**TOWN OF ALGOMA
WINNEBAGO COUNTY, WISCONSIN
PLANNING COMMISSION MEETING
15 N. Oakwood Road, Oshkosh, WI 54904
Wednesday, February 12, 2025 at 6:00 pm.**

RE: **ITEM 4: Discussion and Possible Action re:** Site Plan by petitioner Brandon Robaidek, Robert E. Lee & Associates, Inc on behalf of OSMS Real Estate for an OSMS facility at 200 S. Oakwood Road, Oshkosh, 54904.

OSMS Site Plan Staff Review:

Landscape Plan

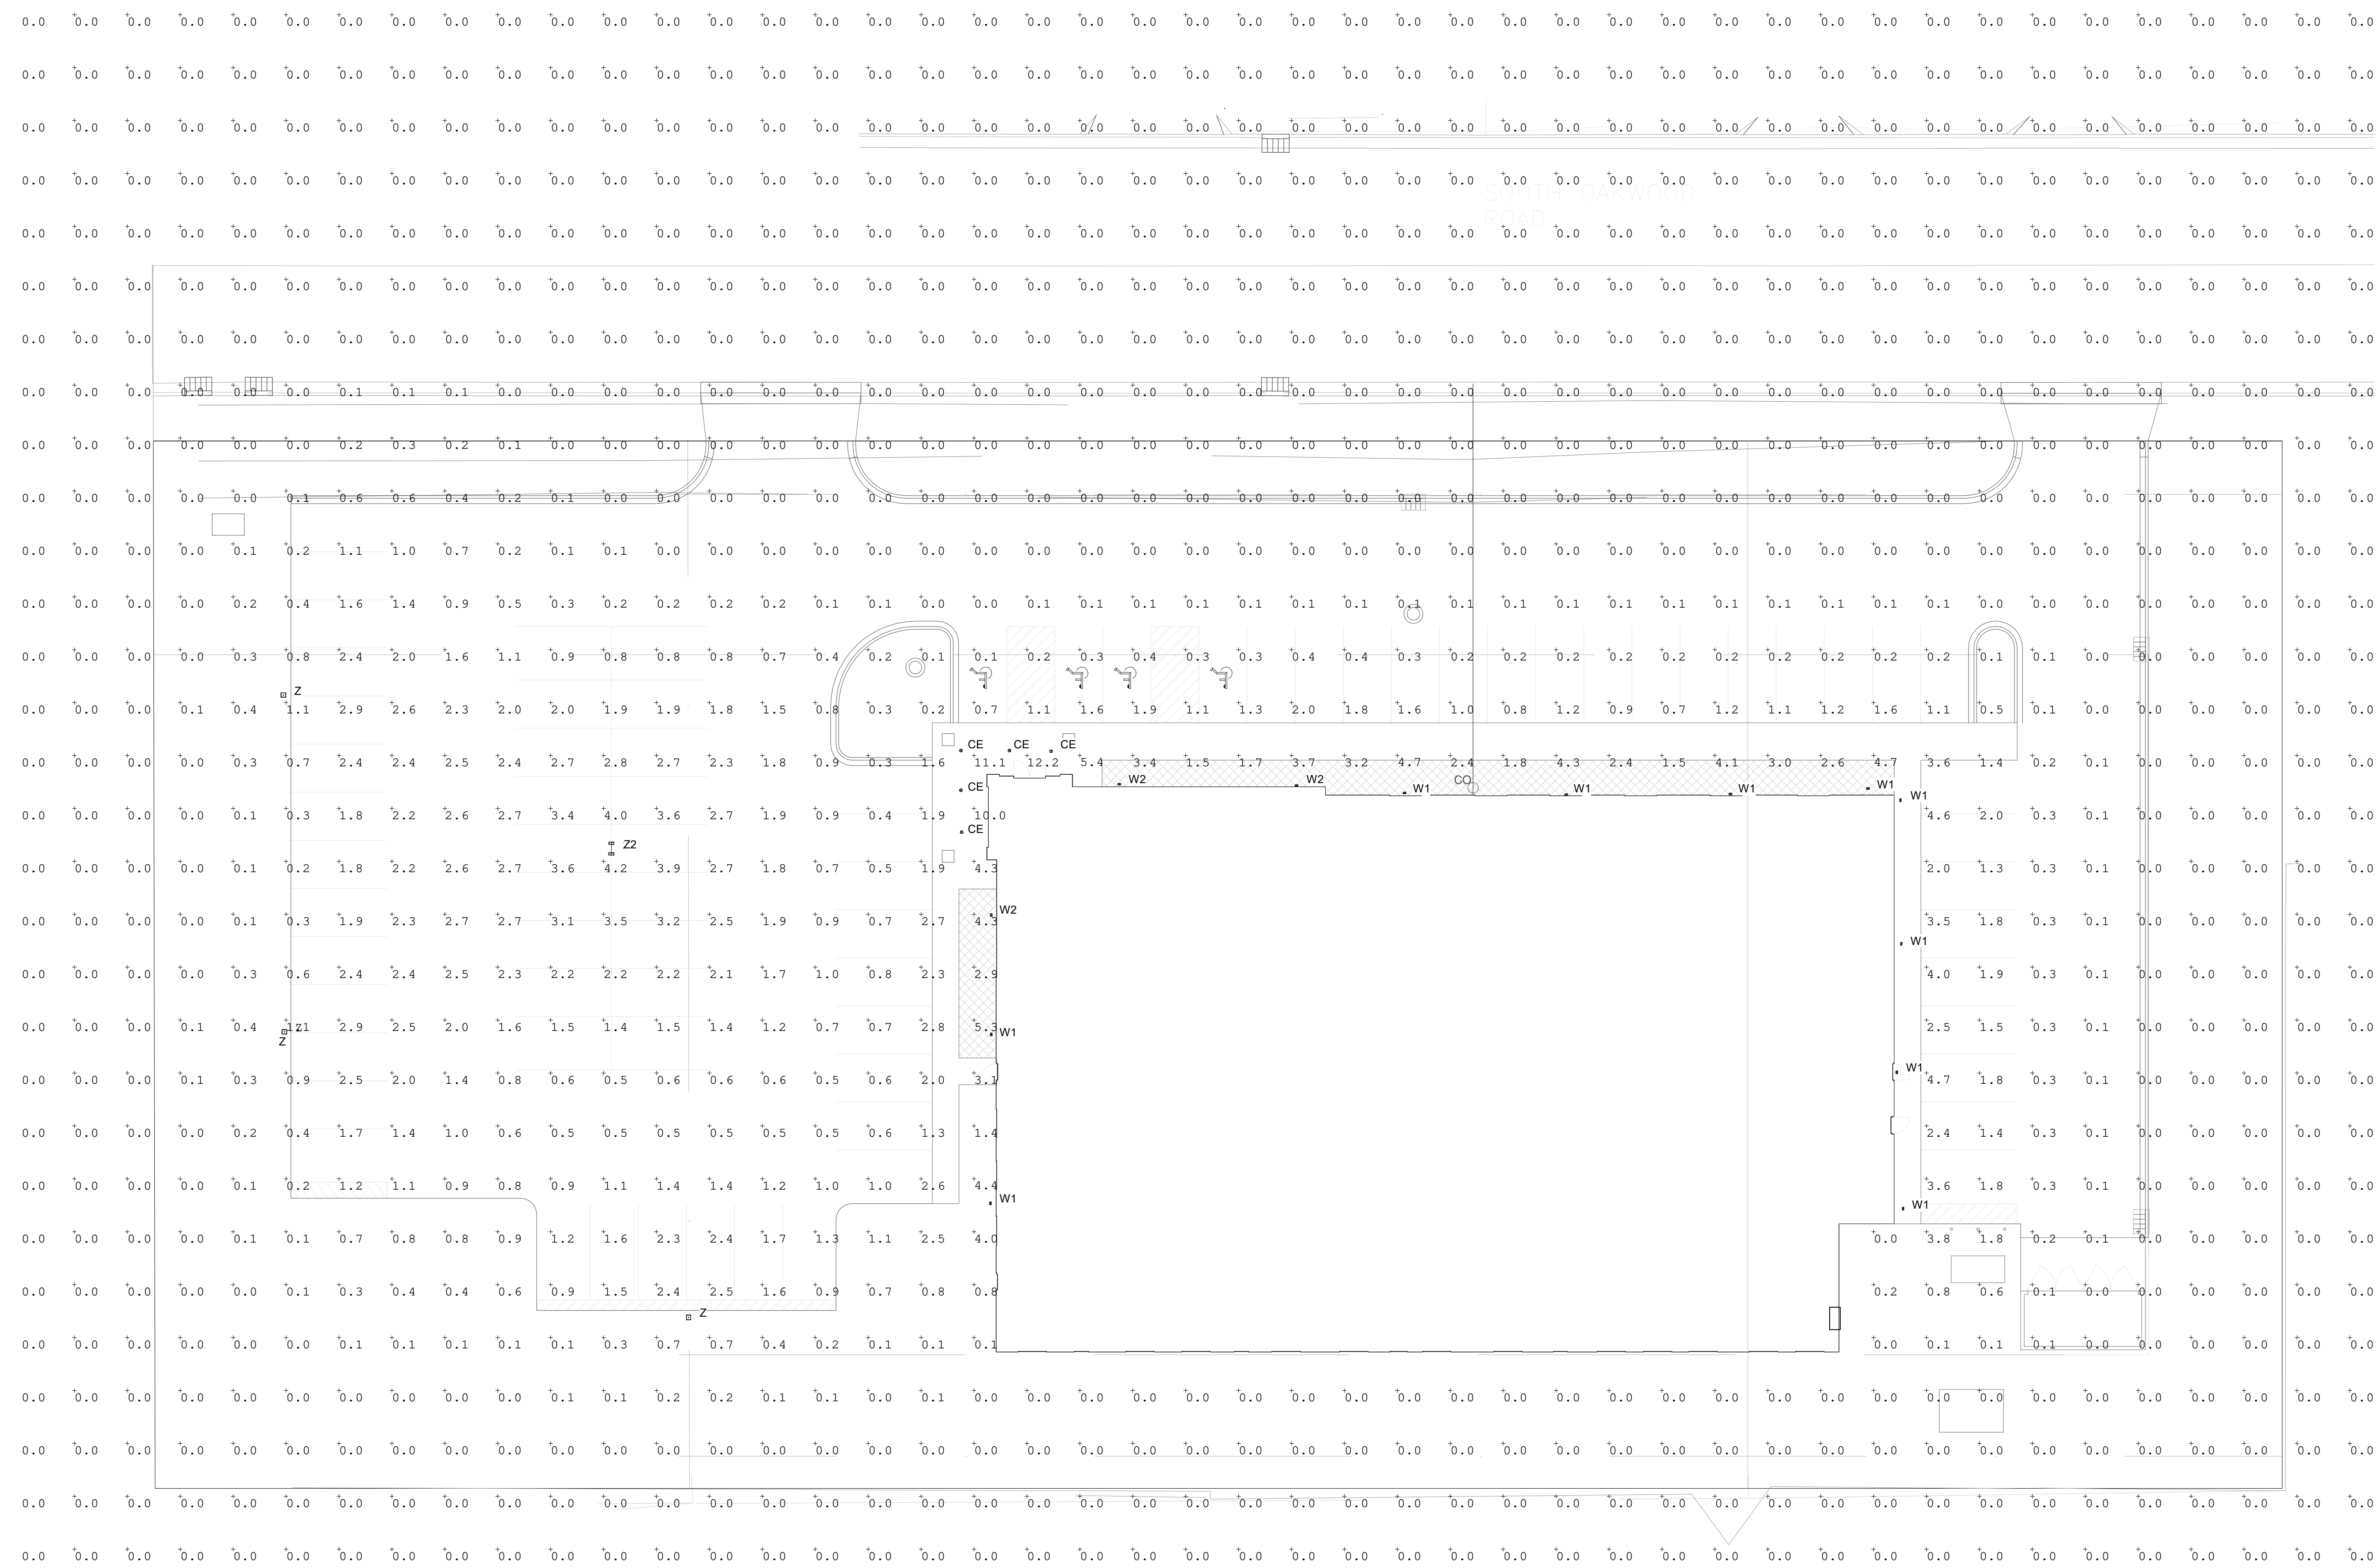
- a. Not less than 15% of the total parcel or lot area shall be devoted to landscaped areas. **MET, 34% green space**
- b. Additional landscaping requirements as determined necessary by the Town Administrator and approved by the Planning Commission and Town Board, including but not limited to the following:
 - 1. Perimeter landscaping.
 - 2. Screening and buffering.
 - 3. Sides of buildings.
 - 4. Parking lots.
 - 5. Heavy equipment and machinery areas.
 - 6. Plant type and size.
 - 7. Materials.
